Diagram 2

6506 Texoma Drive Manvel, Tx. 77578

Master Bath Modifications

254 PLAN

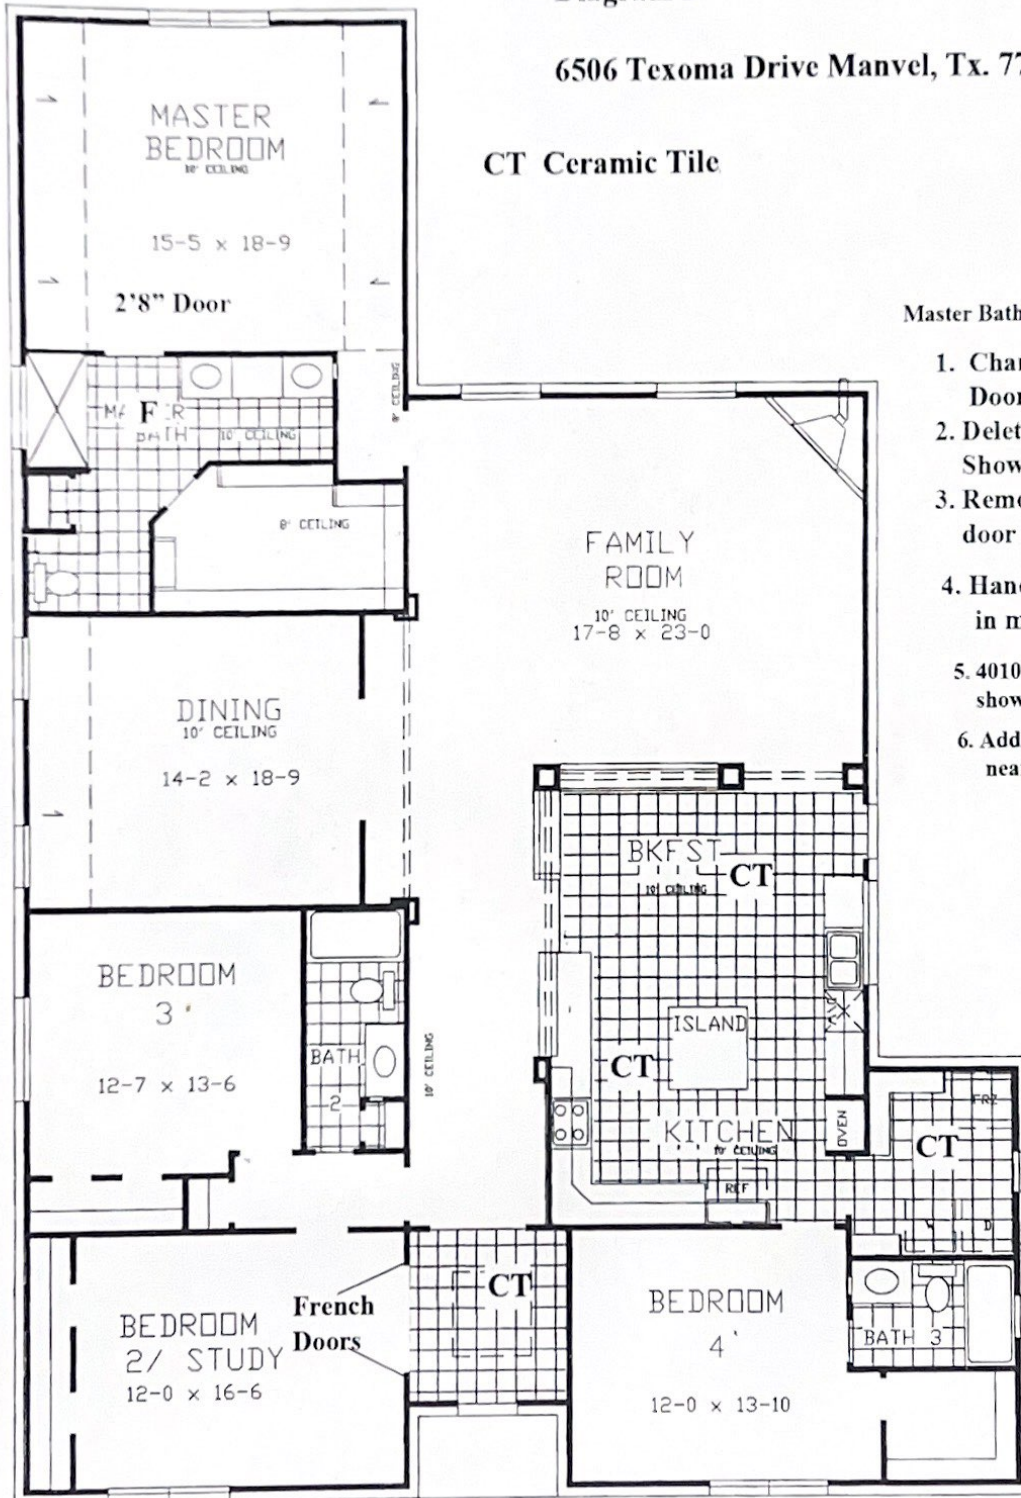
Center 4010 transom  
add a linen closet  
Delete commode wall and door

1. Change Master Bath Door to a 2'8"
2. Delete Tub and make Shower 5'
3. Remove commode door and wall
4. Handicap commode in master bath
5. 4010 transom window over shower
6. Add exhaust fan near shower in MB "F"

Add French Door B2 to Foyer
